Access Compliance Report

Public Rights-of-Way

Intersection ID: 11985	Main Street: MCGILL_GARDEN_WY	Cross Street: N_DAVIDSON_ST	Location: SW
ADA ID: CAAE5F053348	Ramp Type: PerpDiag	Initial Pass/Fail: Fail	Overall Compliance: No
			Severity Score: 21.25

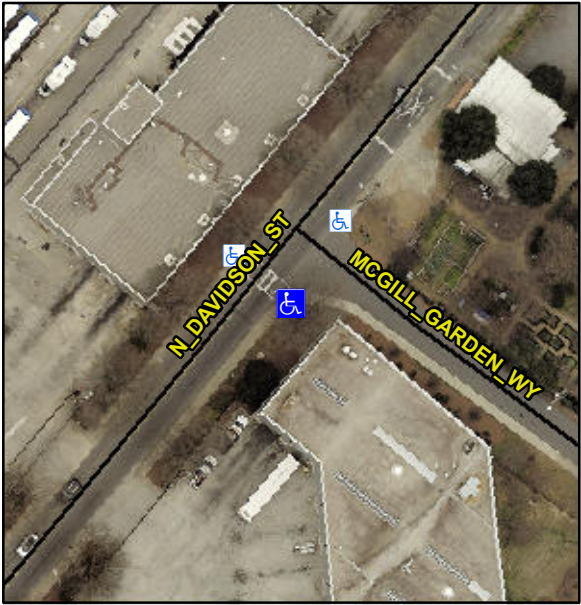
Codes/Mitigation Info/Possible Solution			Field Measurements/Component Compliance		
	Possible Solutions:		Compliance	Description	Data
	Remove & Replace Curb Ramp With Two New Directional Ramps or Equivalent.		No	Ramp Length (in)	50.0
			No	Ramp Width (in)	43.0
			N/A	Flare Type LT	N/A
			N/A	Flare Slope LT (%)	N/A
			N/A	Flare Traversable LT?	N/A
			N/A	Landing Length (in)	N/A
			N/A	Landing Width (in)	N/A
			N/A	Landing Slope (%)	N/A
			N/A	Landing X Slope (%)	N/A
			N/A	Landing Curb? (Y/N)	N/A
			N/A	Shared Landing?	N/A
			N/A	Gutter Ponding?	N/A
			N/A	Gutter Lip Ht (in)	N/A
			N/A	Painted X Walk1?	No
				X Walk 1 Direction	To NE
			N/A	X Walk 1 Width (in)	N/A
				X Walk 1 Slope (%)	3.7
				X Walk 1 X Slope (%)	3.5
			N/A	Ramp inside XWalk1?	N/A
Surveyor Notes: N/A PROW/ADA: Not Found, R304.5.1, R304.2.2			N/A	Flare Type RT	N/A
			N/A	Flare Slope RT (%)	N/A
			N/A	Flare Traversable RT?	N/A
			N/A	DWS Provided?	N/A

N/A	DWS Contrast?	N/A
			N/A	DWS Length (in)	N/A
			N/A	DWS Full Width?	N/A
			N/A	DWS Offset (in)	N/A
			N/A	Gutter Slope (%)	N/A
			N/A	Gutter X Slope (%)	N/A
			N/A	Painted X Walk2?	No
				X Walk 2 Direction	To NW
			N/A	X Walk 2 Width (in)	N/A
				X Walk 2 Slope (%)	2.5
				X Walk 2 X Slope (%)	3.5
			N/A	Ramp inside XWalk2?	N/A
			N/A	Clear Space?	N/A
			N/A	Clear Space to XWalk (in)	N/A
			N/A	Storm Grate/Utility Hazard?	N/A
				Storm Grate/Utility Type	
Total Cost: \$ 3200.00			N/A		N/A
			Yes	Surface Condition? (G/P)	Good
